Enclosed are the meeting minutes for the 116-B-6-1 ISV Demonstration Project and final comments on the 116-B-6-1 Site Characterization Plan from Ward Staubitz (USGS).

Subject: Site characterization plan for ISV demonstration project

SCP-13808, Rev. 1  
Page 15 of 40

FIGURE 11. Water Table Map of the 100-B Area Measured on February 7, 1989

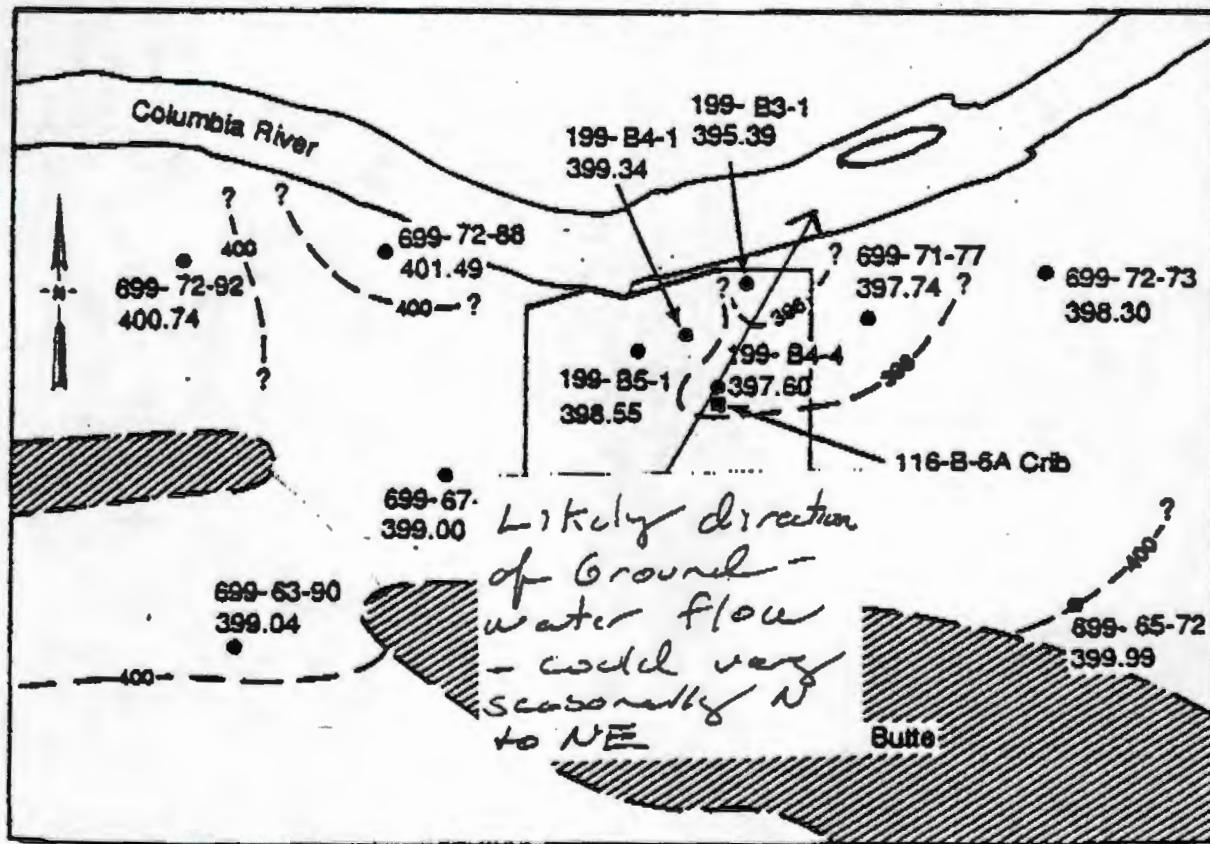
As we discussed on the phone this morning, I am transmitting my comments on the proposed locations of monitoring wells for the ISV demonstration project. The ground-water gradient along streams that serve as ground-water discharge areas is often skewed in the down stream direction. An examination of Figure 11 indicates that ground water may indeed flow in a northeasterly direction in the vicinity of the 100-BC area. Ground-water levels measured in the 300 area indicate that this effect can occur greater than 3000 feet from the Columbia River. We therefore recommend adjusting the well locations noted in Figure 13 to better account for possible northeasterly flow. I have included a copy of Figure 13 with these recommended changes for your information. If you would like to discuss this further, I can be reached at FTS 390 6510.

*Figure 12 does not allow drawing conclusions on larger-term seasonal gradient. Data include "short term" to be specific.*
